# A303 Sparkford to Ilchester Dualling Scheme TR010036

# 9.2 Environmental Statement Table of Errata

#### **Environmental Statement Table of Errata**

Regulation Number:	
Planning Inspectorate Scheme	TR010036
Reference	
<b>Application Document Reference</b>	9.2
Author:	A303 Sparkford to Ilchester Dualling Scheme Project Team, Highways England

#### Appendix C: Figure 2.13 - Signed cycle route

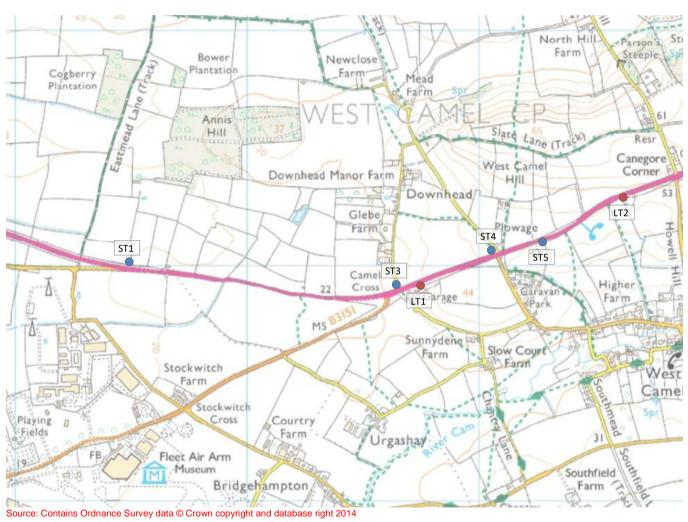
1.6.27	Volume 6.1 Environmental Statement Chapter 2 The Scheme	30	Please provide a key to accompany Figure 2.13 as it is currently not clear exactly what the Figure is showing?	Amended in response to ExA question 1.6.1. A key has been added to Figure 2.13 and the drawing updated with	Figure 2.13 is amended and can be found in appendix C of this document.
